Product Safety Recall

N212342780 Improper Roof Rail Airbag Deployment

Release Date: September 2021 **Revision:** 01
Revision Description: This bulletin has been updated to add the customer letter. Please discard all previous copies of N212342780.

Inspection Area

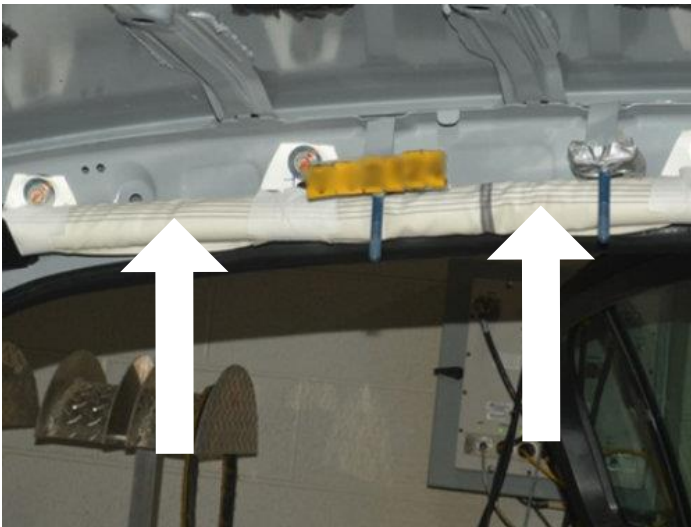
Important: If an air bag twist issue is found per the inspection (which is expected to be a very low occurrence), the technician is **REQUIRED** to take a picture of the condition (before the correction is performed) and attach it to the final job card for any future audit purposes.

5. Inspect the airbag from the upper quarter panel trim to the center pillar. There are two black plastic ramps, one at each end of the inspection area.

Good Example of Stitching

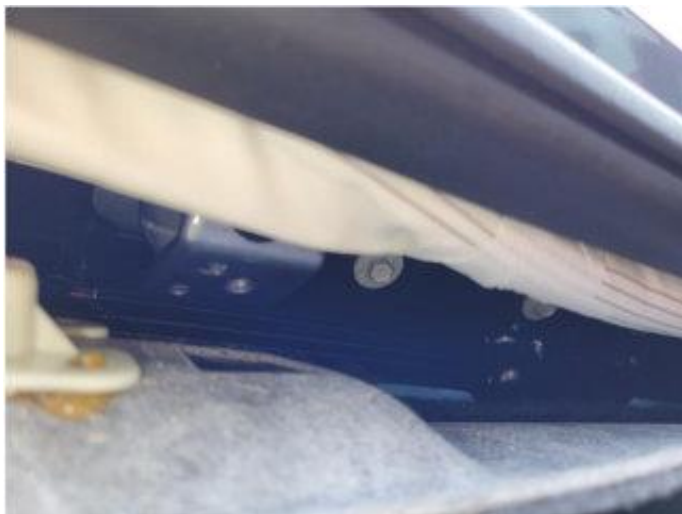
6. Using a small mechanic's mirror, inspect the black four-line stitching located on the inboard side of the airbag fabric.

7. Ensure the lines are facing inboard, straight, and parallel. Perform this inspection on the right and left side roof rail airbags.
 - If the black airbag stitching is straight, parallel, and facing inboard on both airbags, no further action is required. Reinstall the components removed in steps 1-3 above.
 - If a 360-degree twist is detected, proceed to step 8.
8. Remove the front assist handle on the effected side. Refer to *Roof Rail Assist Handle Replacement* in SI.
9. Remove the windshield garnish molding on the effected side. Refer to *Windshield Garnish Molding Replacement* in SI.
10. Lower the headliner as required to access the roof rail airbag attachments forward of the twist condition.
11. Disarm the SIR system.

12. Remove all roof rail airbag push pin and threaded fasteners forward of the twist condition. Refer to *Front and Rear Row Roof Rail Airbag Replacement* in SI.
13. Straighten the twist condition using the black stitch lines for reference.
14. Reinstall the roof rail airbag push pin and threaded fasteners in sequence, from rear to front. Verify the black four-line stitching is straight and parallel after installing each fastener. Refer to *Front and Rear Row Roof Rail Airbag Replacement* in SI.
15. Reinstall the interior trim components and weatherstrips. Refer to the appropriate sections in SI.
16. Rearm the SIR system.
